World Forum for Harmonization of Vehicle Regulations

Proposal for Supplement 15 to the 01 series of amendments to UN Regulation No. 67 (LPG vehicles)

Supplement 15 to the 01 series of amendments to UN Regulation No. 67 (LPG vehicles)

"Annex 2A

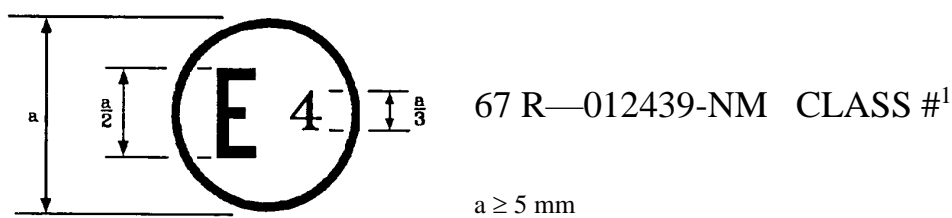
Annex 2A, amend to read:

Arrangement of the LPG equipment type approval mark

$a \geq 5 \text{ mm}$

¹ Class 0, 1, 2, 2A or 3.

² Indication mark of technical modification to be marked only on multivalve or, when approved separately, on pressure relief valve (discharge valve) and pressure relief device.

The above approval mark affixed to the LPG equipment shows that this equipment has been approved in the Netherlands (E 4), pursuant to UN Regulation No. 67 under approval number 012439. The first two digits of the approval number indicate that the approval was granted in accordance with the requirements of UN Regulation No. 67 as amended by the 01 series of amendments. The indication mark of technical modification (A in the example), preceded by the star symbol, is required only for the approval mark of the accessories of the container (multivalve or, when approved separately, pressure relief valve (discharge valve) and pressure relief device)."
